February, 2000

Series 150 Bellows and Guide-plate Improvement

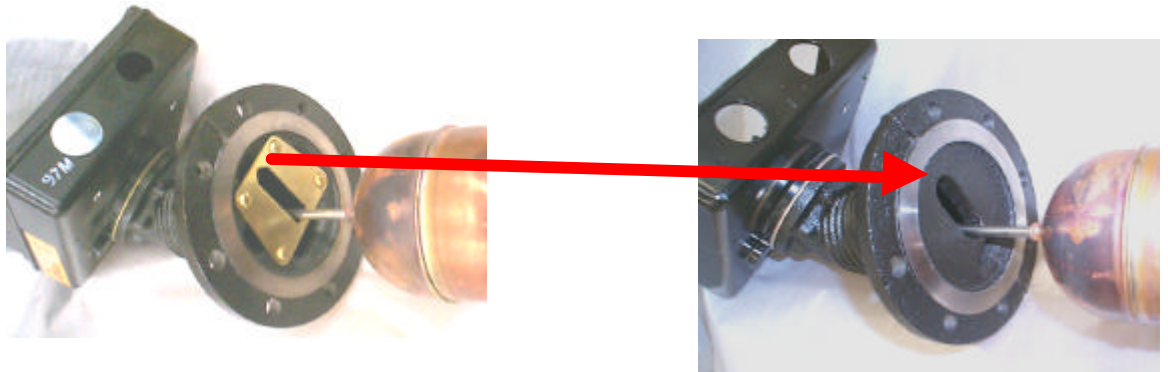
First, to enhance bellows stability, we mechanically secured the bellows assembly directly to the bearing assembly. This improvement was implemented on all Series 150/157 and 150S/157S products in June 1999. (See graphic below).

This change prevents the bellows from deflecting due to increased operating pressure thus maintaining float rod centering in the guide-plate.

Second, we removed the guide-plate, replacing it with a cast in guide system and increased the slot width by 20%. This improvement was recently implemented on all Series 150/157 and 150S/157S products in February 2000. (See graphic below)

This change will also help prevent the float rod from rubbing against the guide-plate.
